Bid Addendum 05

Project: Maritime Museum Education Center,
Beaufort, NC – Construction Phase Services

Date: August 2, 2024

SCO#: 24-27956-01A

C0.00

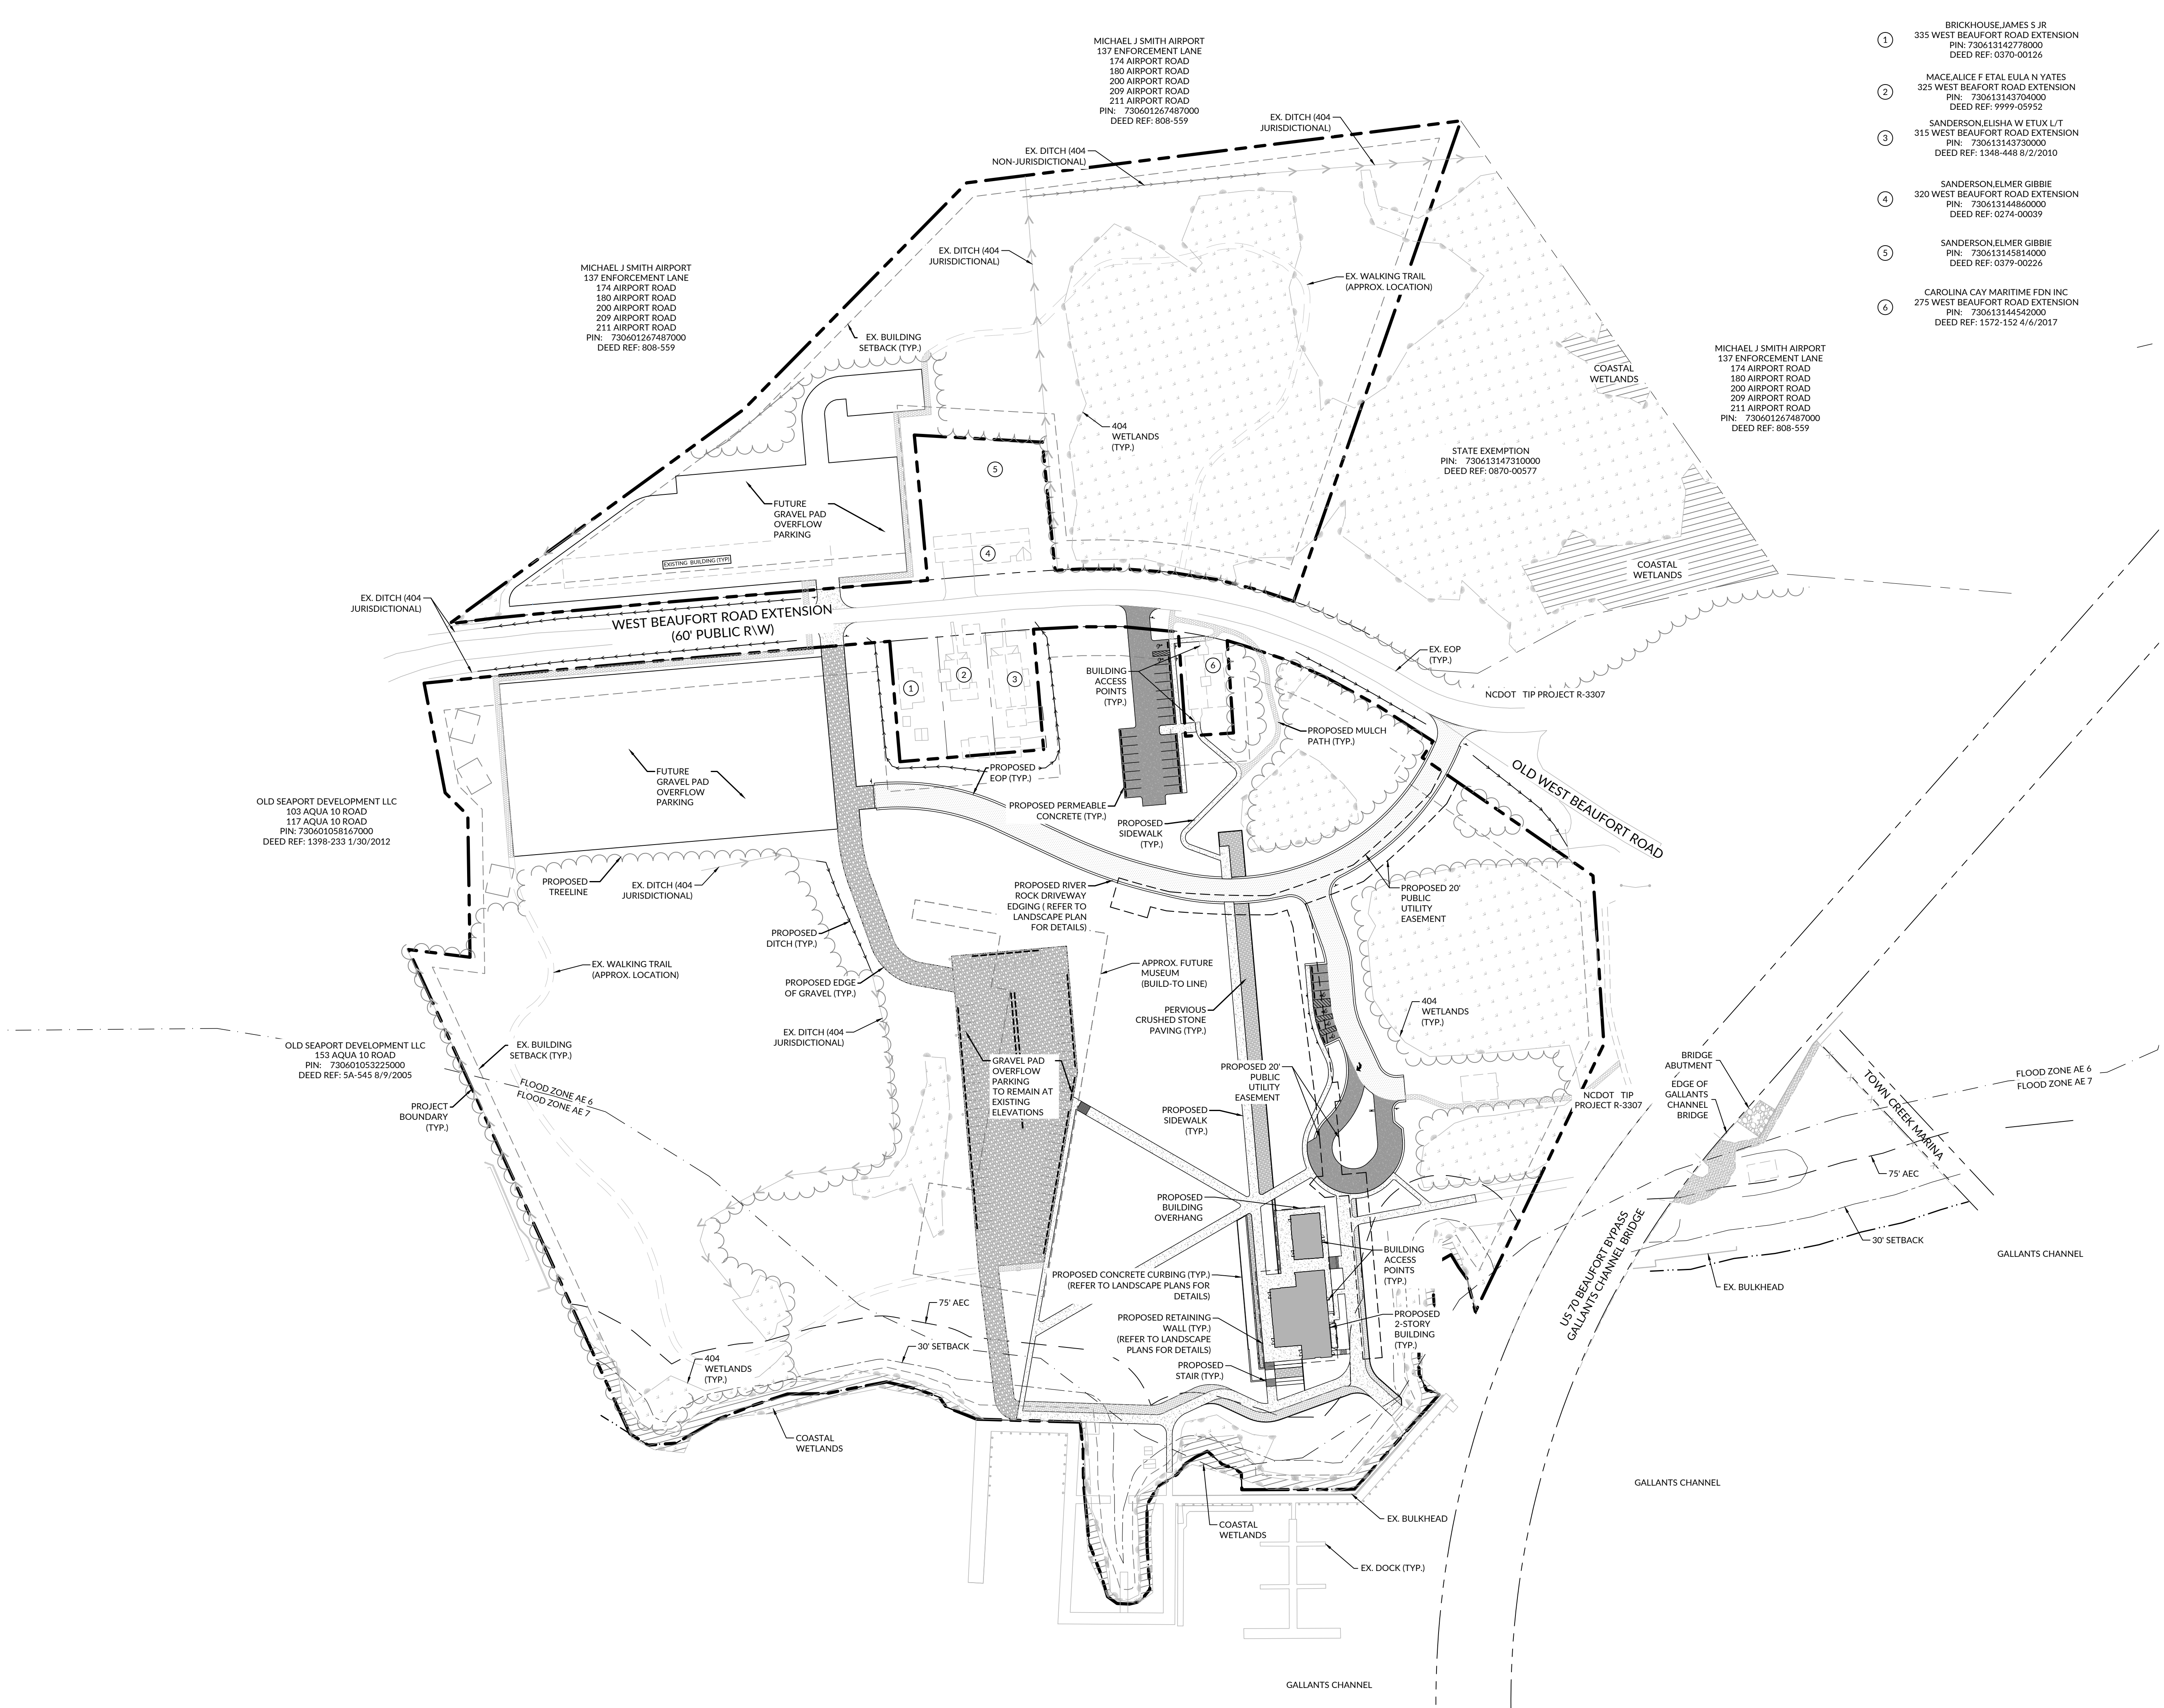
1. Sheet C0.00:
 - a. Road hatches have been modified.
2. Sheet C2.00:
 - a. Road hatches have been modified.
3. Sheet C2.01:
 - a. Road hatches have been modified.
4. Sheet C2.03:
 - a. Road hatches have been modified.
5. Sheet C2.04:
 - a. Road hatches have been modified.
 - b. Text in ADD ALTERNATE 8 has been revised.
 - c. Text in ADD ALTERNATE 9 has been revised.
6. Sheet C3.01:
 - a. Road hatches have been modified.
7. Sheet C4.01:
 - a. Road hatches have been modified.
8. Sheet C4.03:
 - a. Road hatches have been modified.
9. Sheet C5.03:
 - a. Road hatches have been modified.
10. Sheet C7.00:
 - a. Road hatches have been modified.
11. Sheet C7.01:
 - a. Road hatches have been modified.
 - b. Manholes and sanitary sewer lines that are not a part of the project have been removed.
12. Sheet C9.00:
 - a. Gravel Pavement Detail has been added.

ADD ALTERNATE PLAN

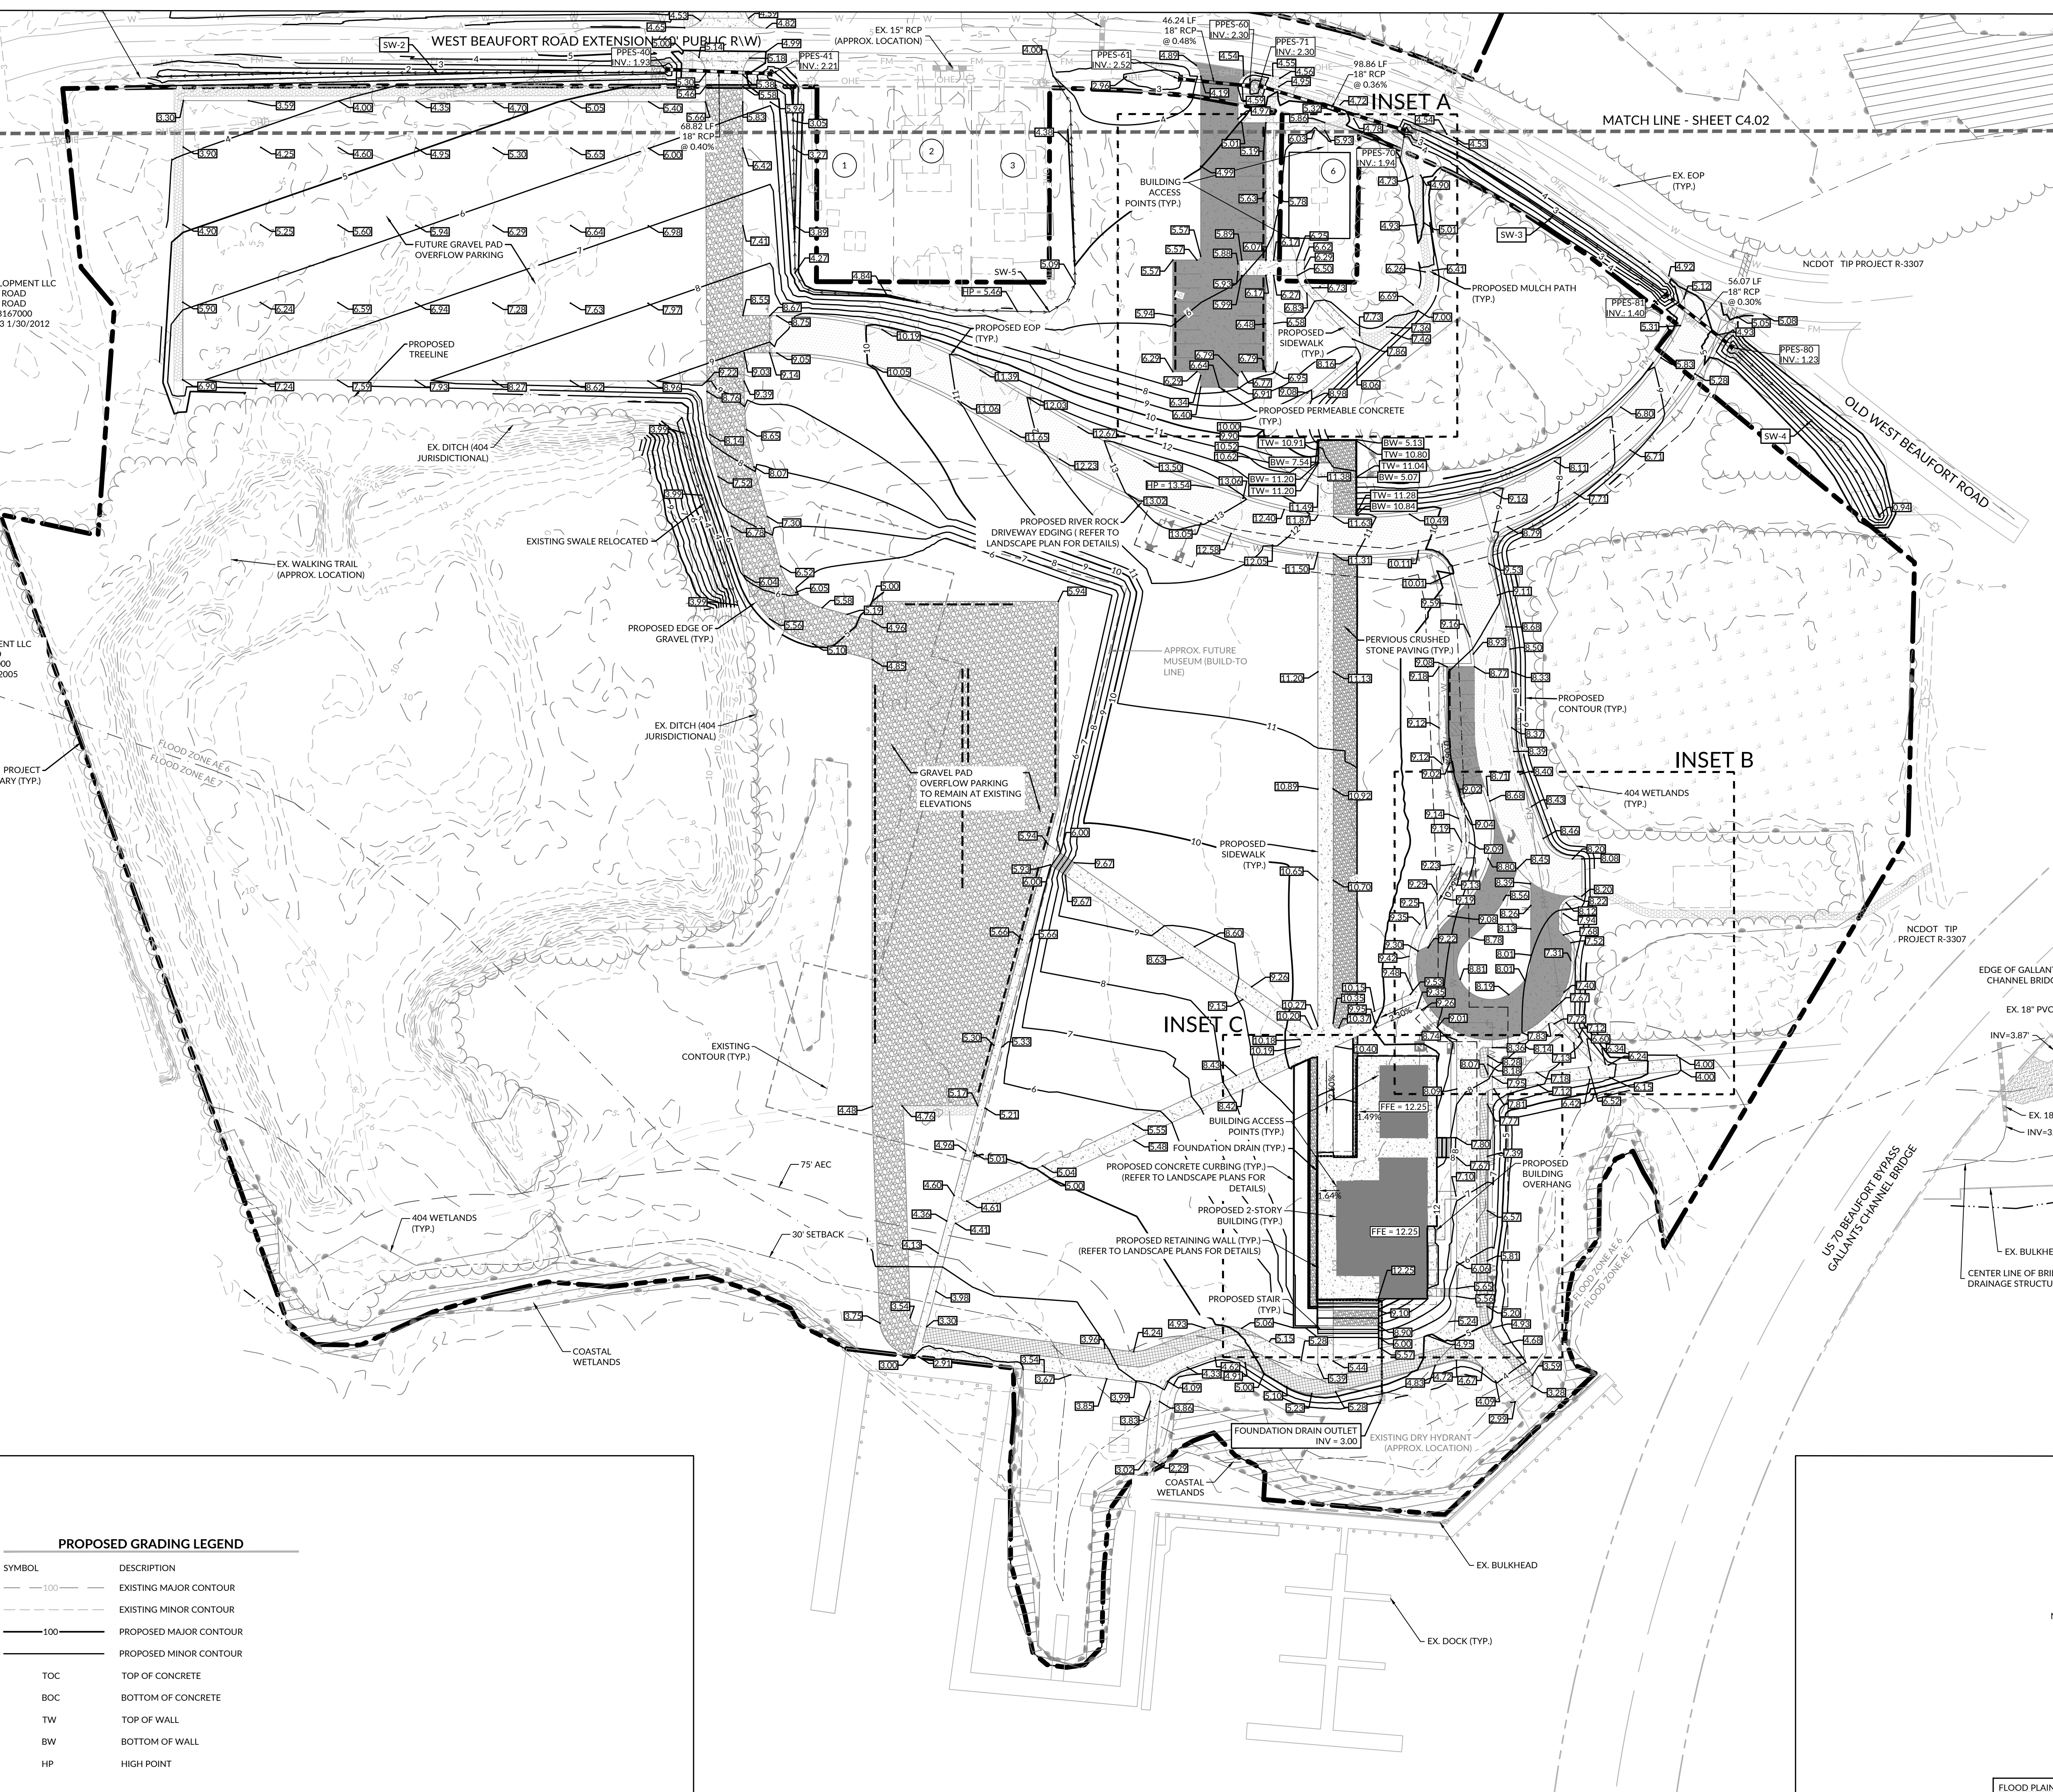
3. **QUESTION:** Alternate #10: See attached [indicating **Lot 1A**] – this parking lot is designated pervious concrete within Civil drawings. Is this parking lot to be included in Alternate #10 – permeable pavers in lieu of pervious concrete?

4. **QUESTION:** Alternate #10: See attached [indicating **Lot 1B**] – are the paver-hatched parking stalls base bid?
 - a. **RESPONSE:** No. Refer to attached sheet C2.04 - Add Alternate Plan; and refer to attached sheets L3.01, L3.02, and L3.03, which have been revised for clarity. The parking stalls in Lot 1B are included in Alternate 10; but pervious concrete is in the base bid, while pervious pavers are in the Alternate.

7. **QUESTION:** Alternate 10 The area highlighted is just the cul-de-sac, drop off area. There are more areas shown as pavers in the original plans. Please verify: Parking lot 1A, 1B, and Cul-de-sac are to all be pervious concrete in the base bid. Alternate 10 only refers to pricing of permeable pavers on the cul-de-sac as shown on Addendum 3. Plan sheet attached for clarity.

- a. **RESPONSE:** No. Refer to attached sheet C2.04 - Add Alternate Plan, which has been revised for clarity. Lot 1A is not included in Alternate 10.

- a. **RESPONSE:** Refer to attached sheet C2.04 - Add Alternate Plan; and refer to attached sheets L3.01 and L3.03. Lot 1A is not included in Alternate 10. Both the cul-de-sac and Lot 1B are permeable concrete in the base bid and permeable pavers in Alternate 10.
